CHANGES AND ADDITIONS
TO PARTS BULLETINS

1001	Issue 1	1067	Issue 2	1090	Issue 2
1012	Issue 2	1080	Issue 1	1093	Issue 1
1038	Issue 2	1082	Issue 2	1100	Issue 2
1052	Issue 1	1088	Issue 2	1117	Issue 2
1064	Issue 2	1089	Issue 1

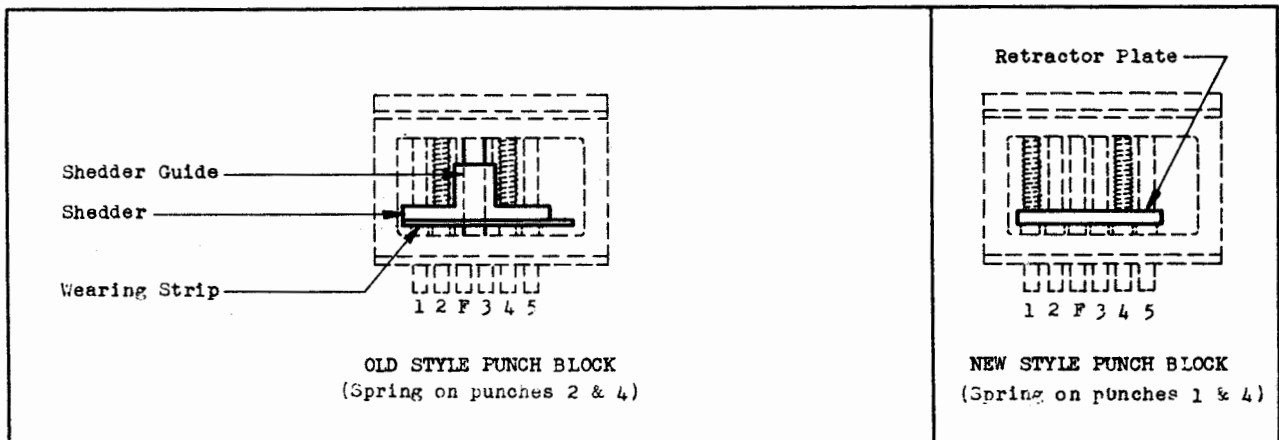
The sketches below illustrate the difference between the old and new style assemblies, and it should be noted that the shedder and wearing strip are replaced by a retractor plate, and the shedder guides are not used. The shedder and wearing strip are no longer being furnished. When it is desired to replace a shedder or wearing strip, a retractor plate should be ordered instead.

The punch block assemblies shown in the above bulletins have been redesigned and assigned new assembly numbers. Old style punch block assemblies are no longer furnished. On orders for old style blocks, new style assemblies which are fully interchangeable with the old style will be furnished.
